# 802.3dj - Comments D1.1

## Annex 179A - TBDs

Chris DiMinico  
PHY-SI LLC/SenTekse LLC/MC Communications  
[cdiminico@ieee.org](mailto:cdiminico@ieee.org)

Figure 179A-3—Host-Nominal to Host-Nominal, Cable assembly, and test fixture

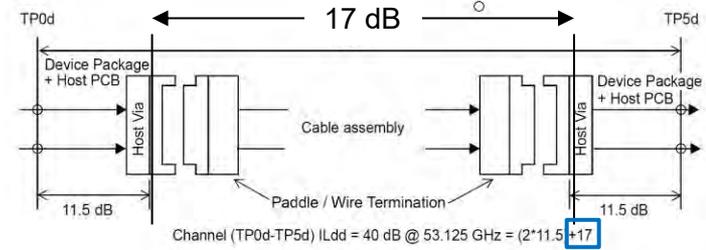
179A.4 - Adopt assumed mated connector IL of 2.45 dB

NOTE (TBD)—2.7 dB MCB PCB ILdd includes the RF connector (up to the RF connector reference plane). The MCB via allowance is 0.8 dB.

**Current D1p1 >> Figure 179A-3—Host-Nominal to Host-Nominal, Cable assembly, and test fixture insertion loss at 53.125 GHz**

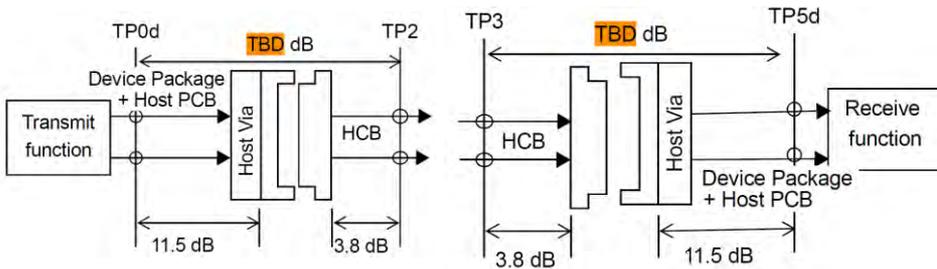
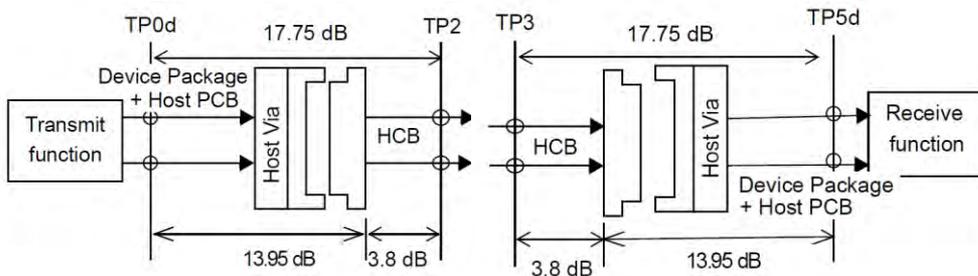
Defining a "host channel" as "controlled impedance PCB, device package, and host connector footprints" is not realistic. There may be cables in the host, and the connector loss is significant and will not be the same for all connectors, cabled and not, on either side of the board... The connector is part of the host and its loss should be included. This will simplify things: there will be only two parts making up the TP0d to TP2 channel: the host and the HCB traces.

Define the host channel from TP0d to the outside of the connector, adding the nominal connector loss (2.9 dB because hundredths of a dB are to be avoided) to the values in Table 179A-1.

Proposal to change host channel definition - Figure 179A-3 figure revised to move arrows to outside of plug. Values with 2.45 dB assumed connector included in figure.

Figure 179A-3—Host-Nominal to Host-Nominal, Cable assembly, and test fixture insertion loss at 53.125 GHz

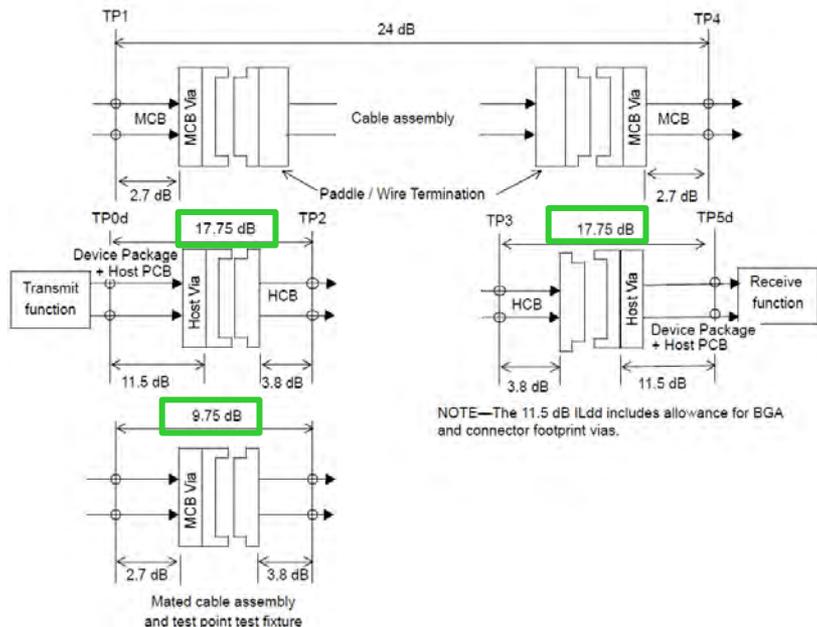
# Comment#519: max TP0d-TP2 or TP3-TP5d and Comment#520, 126 MTF IL- 179A.5

- 179A.5 - TBDs; Mated Test Fixture 9.75 dB @53.125 GHz, TP0d-TP2, TP3-TP5d (Table 179A-1)

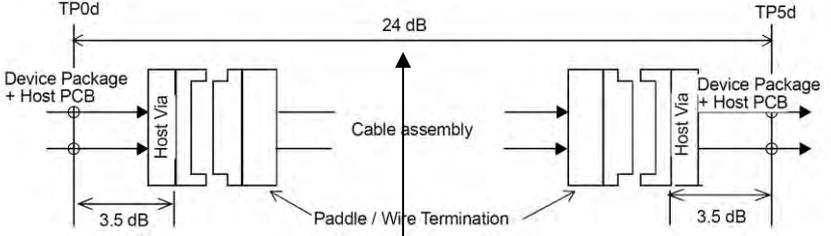
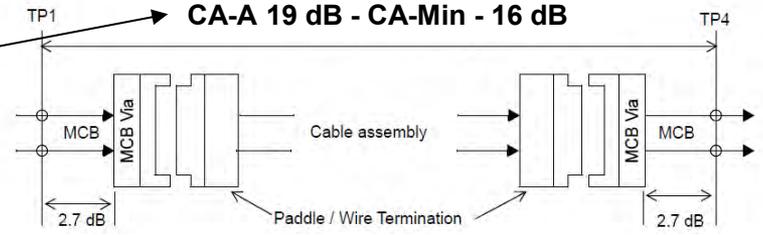
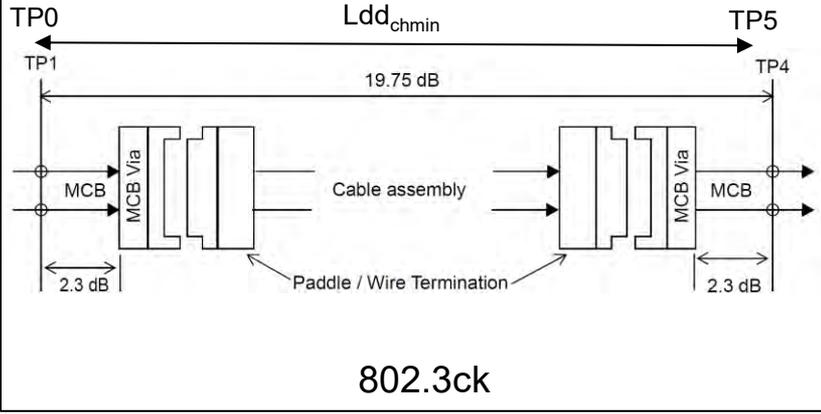
# Comment#521,461 179A.5 - TBDs; Min Channel TP0d-TP5d and Min CA ILdd

Min channel TP0d - TP5d with max cable IL  
(consistent with 802.3ck method)

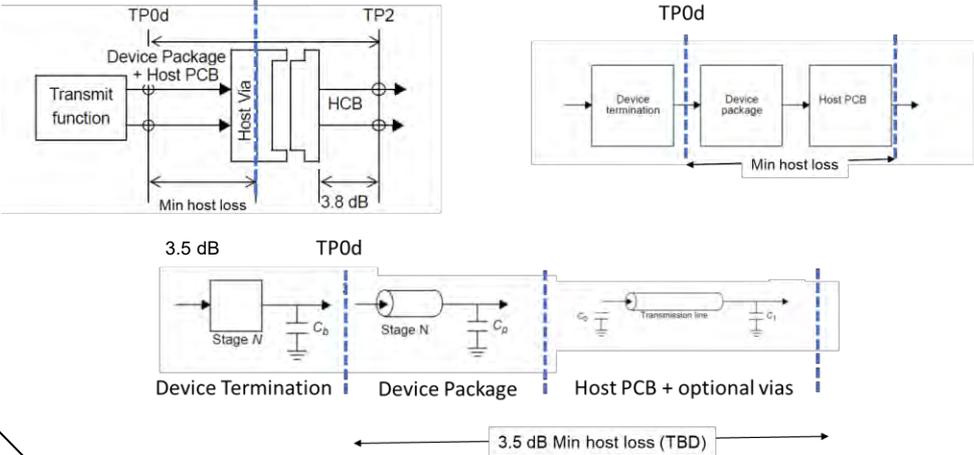
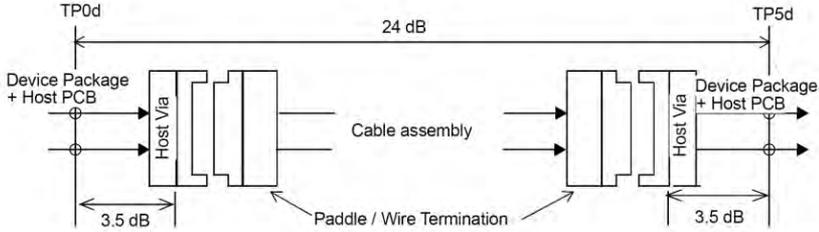
Insertion loss plots are not indicative of COM or performance because of cable vs PCB choices, electromagnetically compensated connectors, top-package connections, or other design choices. In addition, the host MDI connector may not have a connector footprint. Insertion loss limit mask plots are not easily determined because of the variety of design choices. In addition, the use of the words "maximum" and "minimum" are imperative words that are often circumvent the informative nature of the specification. A suggested range is more appropriate for an informative specification.

Min Channel TP0d - TP5d with max cable IL (consistent with 802.3ck method)
